POWER STROKE DIESEL V8

**1999.5
DIT Engine
Update**

1999.5 FORD CHANGES

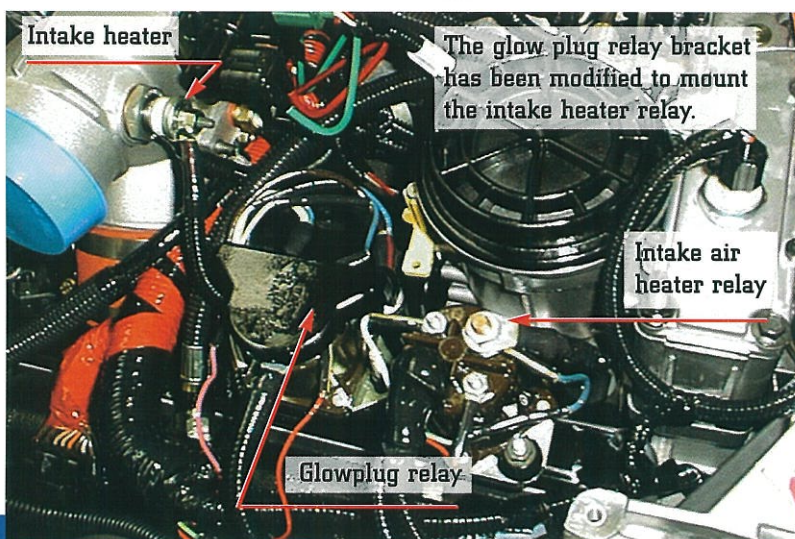
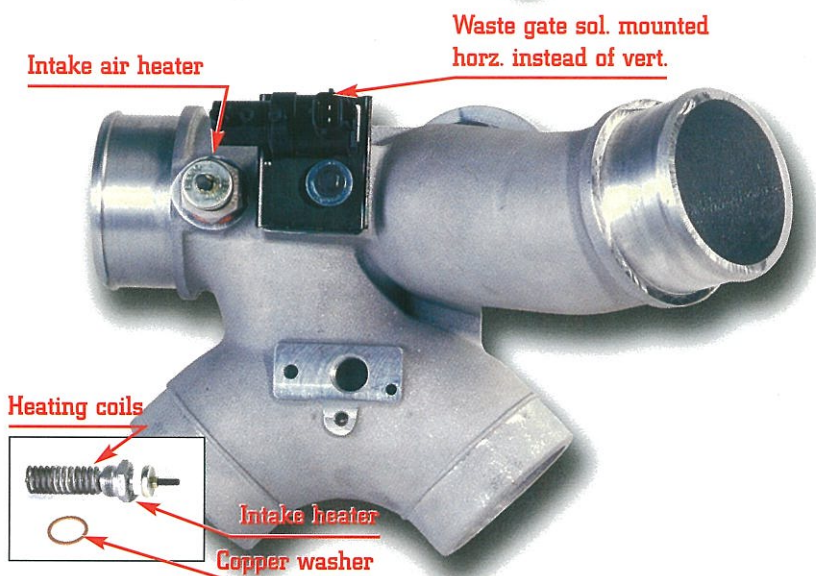
The turbo charger has been changed to improve efficiency. The diameter of the turbo compressor outlet, and the size of the compressor have increased to improve air flow capabilities of the turbo. Due to the increase in size, the new turbo is mounted on a taller pedestal to provide adequate clearance. A new exhaust inlet adapter has been designed to allow access to the fuel pressure test port at the rear of the head. The new exhaust inlet requires new exhaust up-pipes. The Econoline uses the new larger, taller turbo without the waste-gate or charge air cooling provisions.

A new CAC crossover has been developed for the new turbo and incorporates a PCM controlled intake air heater. The heater is installed in the air inlet to the engine (after the charge air cooler) side of the CAC crossover. On the Econoline the heater is in the "Y" pipe downstream of the turbo. The new intake heater is used to heat the air before it reaches the combustion chamber in the engine during cold startup to reduce cold smoke. Current to the intake heater is switched on/off by a PCM controlled relay, similar to the glow plug relay. In order for the relay to be activated the following conditions must be met: fast idle must be engaged, glow plugs must be off, PCM voltage must be between 11.8–15 volts, EOT (Engine Oil Temperature) must be below 55°C (131°F), and engine speed must be above 1000 RPM. In order for fast idle to be engaged the following conditions must be met: the vehicle must be in park or on a manual transmission the parking brake must be set, EOT must be below 70°C (158°F), IAT (Intake Air Temperature) must be below 0°C (32°F) for 1000 RPM and -10°C (14°F) for 1100 RPM, brake pedal must not be depressed, and accelerator pedal must be at idle. A 90° angled fitting for the map hose has also been installed so that a common straight MAP hose can be used for both the Econoline and the "F" series. With the increased turbo height and repositioning of the waste gate solenoid the wastegate hoses have also changed to fit the relocated components.

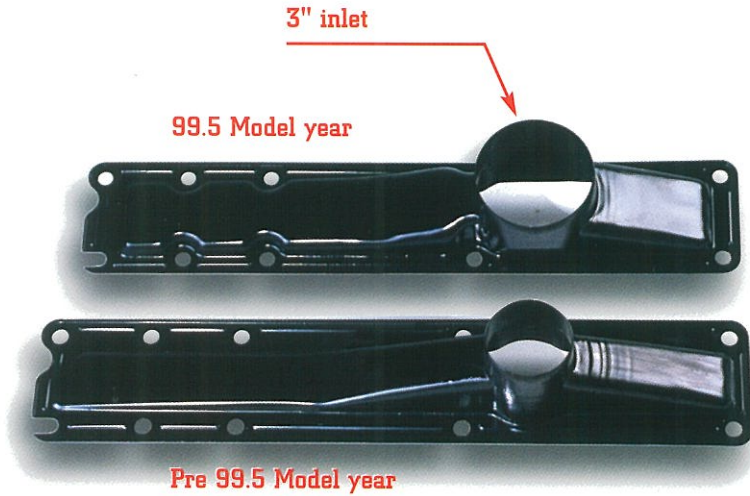
Both the Econoline and the "F" Series use a new intake cover with 3" inlets into the heads for better flow to the combustion chambers. The new cover has had no modifications to length or bolt pattern. With this change, the CAC to intake hoses are now straight with 3" diameters on both ends. These hoses have no hump between the two components. On the non charge air cooled Econoline engines, an aluminum "Y" pipe with 3" inlets and outlets is now used.

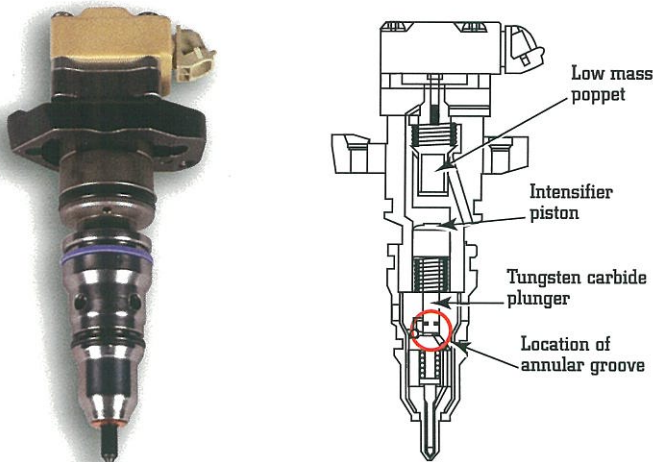
Due to the changes in turbo height, the turbo air inlet duct for both the Econoline and "F" Series have changed.

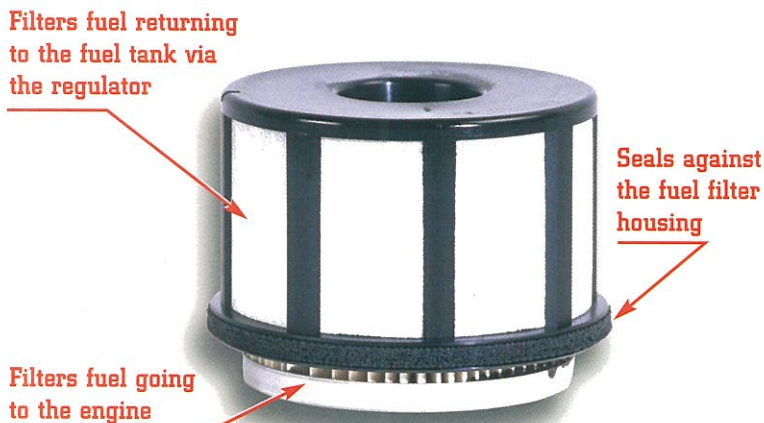
A new injector has been released with the following changes:

- Low mass poppet to increase efficiency and lessen noise.
- Tungsten carbide coating on the injector plunger and barrel. This coating lessens the chance of injector damage caused by low lubricity fuel and water.
- The annular groove that is cut into the plunger is wider than in previous models so that the time between the first and second shot of injection is increased, this helps emissions.

Due to the injector changes a new high pressure oil pump is being used. The new high pressure pump has a higher flow rate (from 6.8cc per revolution to 7.2cc).
